AGENDA MEMORANDUM

Kingsley Heights

Request for a plat waiver for Off-Road Multi-Use Trail and One Way Cycle Track Construction in Section 3.8.3.C of the Unified Development Code

Exhibit A

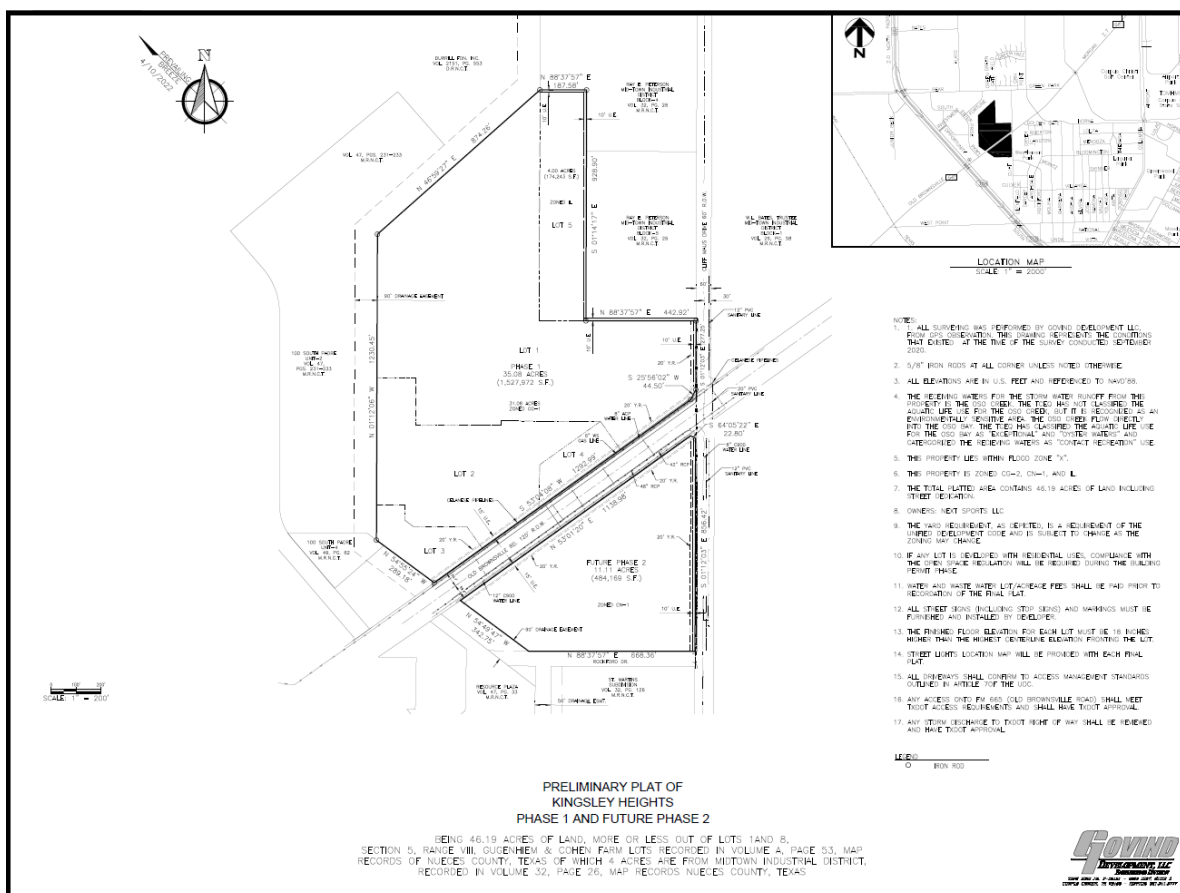
1. UDC Section 3.8.3.C.2 states that the preliminary plat is consistent with the Comprehensive Plan, Utility Master Plans and any other adopted plans. **This includes**

2. The Off-Road Multi-Use Trail and the One-Way Cycle Track are clearly defined on the Bicycle Mobility Plan. Not building these tracks will remove the connectivity of bicycle network and future construction of three quarters of a mile that are part of the trail.

3. Building these tracks will promote future pedestrian and bicycle traffic as the area develops. A sports complex and hotel are proposed. These uses would generate pedestrian and bicycle traffic. The proposed trail and track would link to West Oso High School and the adjacent neighborhood north of Bear Lane, and Westhaven Park and adjacent La Molina neighborhoods east of Cliff Maus Dr. There is an existing crosswalk across Cliff Maus Dr. from Rockford Dr. to Westhaven Park.

4. There are two bus stops on Bear Lane which support pedestrian and bicycle intermodal connections in close proximity to the Off-Road Multi-Use trail. One bus stop in front of West Oso High School is approximately 371 feet from the proposed off-road multi-use trail and another is 1000 feet to the east of the proposed trail. Each of these stops has 11-17 daily boardings. A third bus stop on Old Brownsville Road is 472 feet from the proposed trail which has 18 – 33 daily boardings.

5. The drainage ditch berm width is approximately 35 feet and is wide enough that permits the building of the Off-Road Multi-Use Trail.
6. Rockford Dr. (a paper street with utilities) is 50 ft. in width by 600 ft in length and would need to be constructed with the final plat in Phase II of the development. This would require additional dedication of 12 feet of ROW to accommodate the One-Way Cycle Track. The street segment is short and dead ends at the drainage. Staff recommends, in lieu of construction of Rockford Dr. and the One-Way Cycle Track, that the Off-Road Multi-Use Trail be continued within the Rockford Dr. ROW to connect the trail along the ditch to Claud Maus Dr. This would result in cost savings in not constructing a full road section yet providing pedestrian/bicycle access meeting the intent of the Mobility Plan.

- **Disapproval of the waiver** request for the construction of Off-Road Multi-Use Trail and
- **Approval of the waiver request for the construction of One-way cycle track (both sides) with the condition that an Off-Road Multi-Use Trail be constructed instead, and the street construction of Rockford Dr. be waived.**
